*Fédération
Aéronautique
Internationale*

CIVA Rules Committee Report

Agenda item 8.1

Version 1 / 14 October 2024

Figure 21 article B.9.5.2.e) Section 6 part 1 page 87 and figure 18 article B.9.5.2.f) Section 6 part 2 page 81

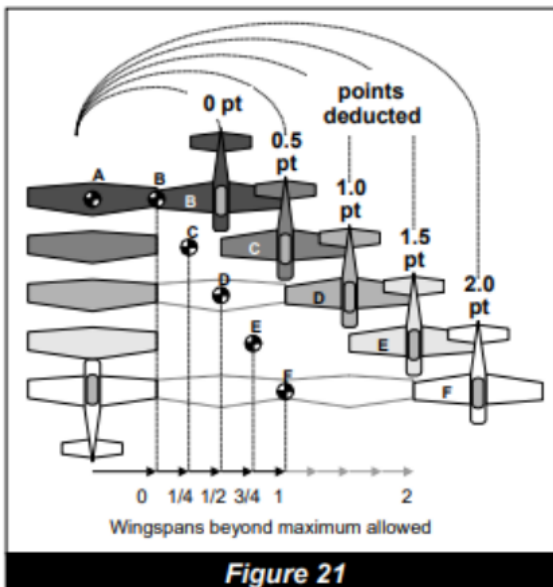
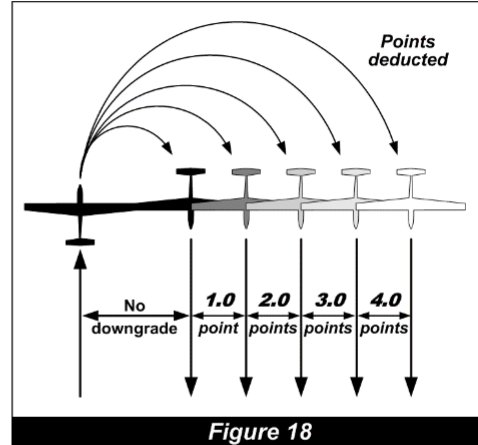
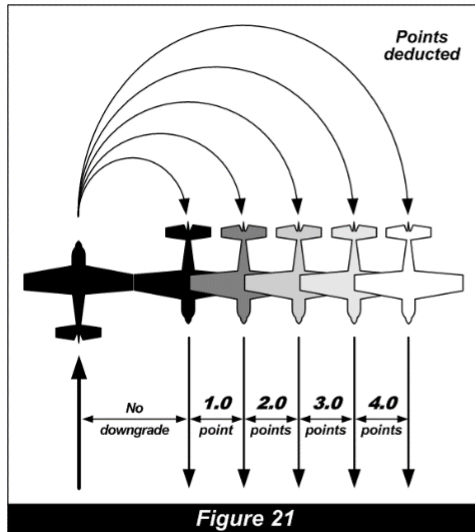
In both cases the diagram (Figure 21 for part 1 and Figure 18 for part 2) is as shown. The downgrades illustrated are however all only half of the correct values.

This proposal concerns the Stall Turn text and diagram in part 1 and part 2. In both cases the instruction requires the judge to assess sideways shift of the aircraft “point of rotation” mid-way during the required 180° yaw. The drawing shows a CG symbol  for this imaginary point and the same (power) diagram is used in each document.

It must also be noted that for many years the diagram has shown incorrect downgrade values that are HALF the amount described in the text. This is corrected in the proposal.

With reference to the CG rotation point removed from this explanation it becomes highly advantageous to simplify both of the diagrams accordingly.

Replacement diagrams are proposed. In each case ambiguities have been removed and only the initial up-line and possible down-lines are used to classify the appropriate downgrades.

RC discussion: Incorrect claim that current illustration and text are not consistent with each other. Therefore, the proposal can be address at Plenary, redefined as two separate, unrelated proposals subject to two independent votes:

- 1. Change explanation logic / what judges need to pay attention to.**
- 2. Double penalty points vs current rules.**

As the aircraft (glider) nears the point where it would stop climbing, it must yaw through 180° to the left or right to achieve a vertical down-line. Ideally the aircraft (*glider*) rotates without sideways motion and descends on the same axis. When rotation is complete the lateral distance between the up-line and the down-line must not exceed one wingspan of the aircraft (*glider*). The downgrade for a detected deviation is one (1) point for each additional lateral half wingspan, or part thereof, to a maximum of four (4) points.
